ENCLOSURE 1

PROPOSED TECHNICAL SPECIFICATION REVISIONS
BROWNS FERRY NUCLEAR PLANT
UNITS 1, 2, AND 3
(TVA BFNP TS 178 SUPPLEMENT 1)

ENCLOSURE 2
DESCRIPTION AND JUSTIFICATION
(TVA BFPN TS 178 SUPPLEMENT 1)

Figure 3.6-1

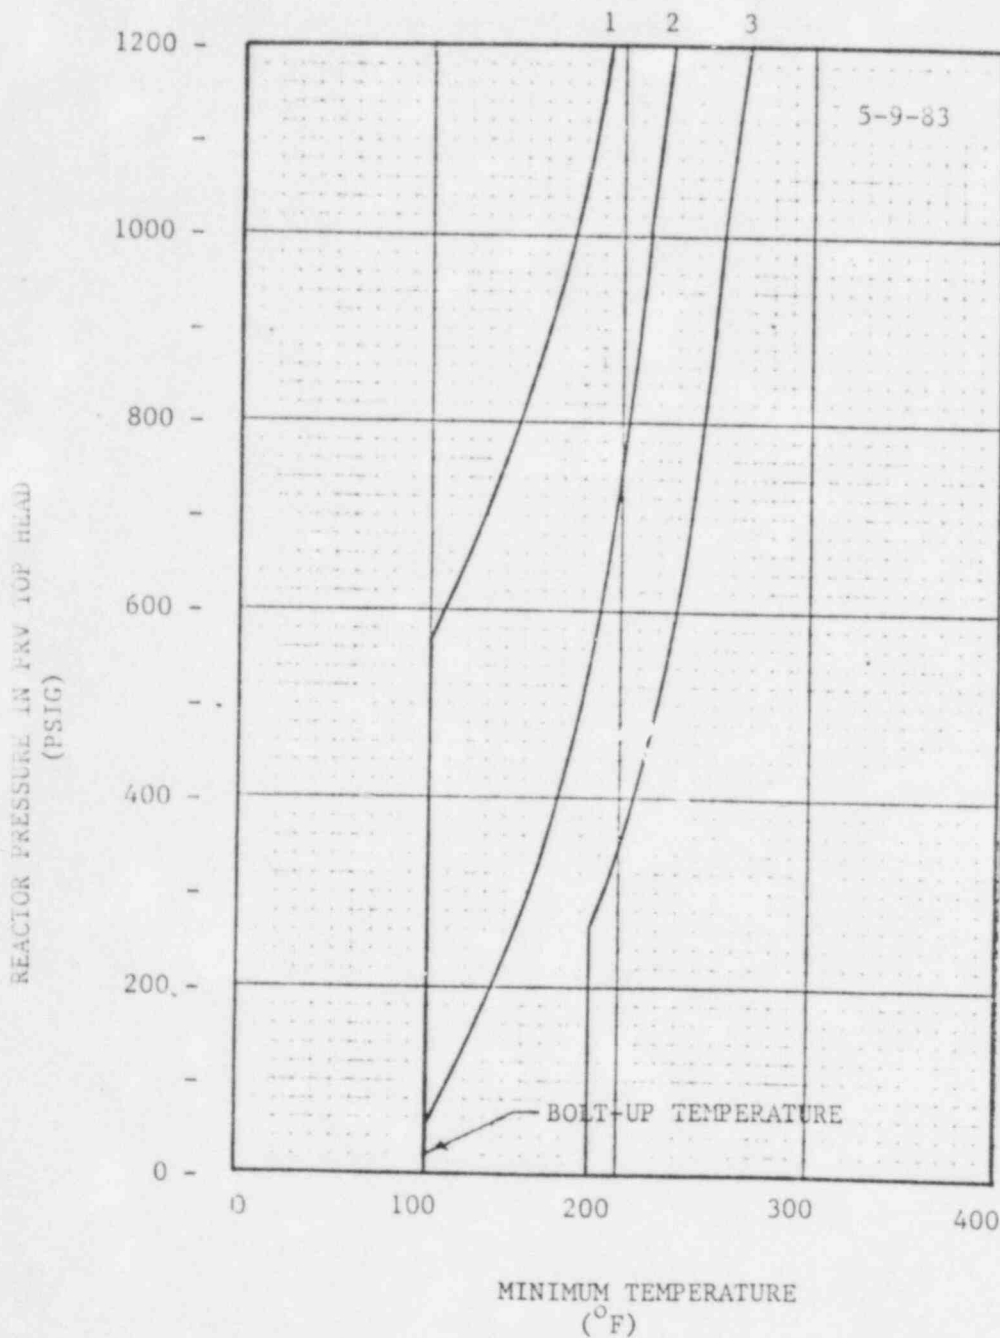
This is a proposed change to figure 3.6-1 for all three units. This figure shows curves of minimum temperatures as a function of reactor pressure for pressure tests such as ASME Section XI, for mechanical heatup or cooldown following nuclear shutdown and for core operation (criticality). The existing figure 3.6-1 is applicable only through 4.0 Effective Full Power Years (EFPY). This proposed change extends applicability through 6.0 EFPY.

This existing figures (through 4.0 EFPY) are nonconservative for application beyond 4.0 EFPY. These proposed revisions are submitted to maintain the margin of safety provided by the earlier version of Figure 3.6-1. This revision is needed to accommodate the shift in RT_{NDT} necessitated by increasing neutron fluence on the pressure vessel walls as the pressure vessel ages. The revision shifts RT_{NDT} 36°F which is a 6°F increase over the previous revision to figure 3.6-1. This revision is necessary to maintain the same degree of overall plant safety.

These curves include sufficient margin to provide protection against feedwater nozzle degradation. The curves also include a 36°F shift in RTNDT of the reactor vessel beltline material. This shift will allow these curves to be used up to 6.0 EFPY
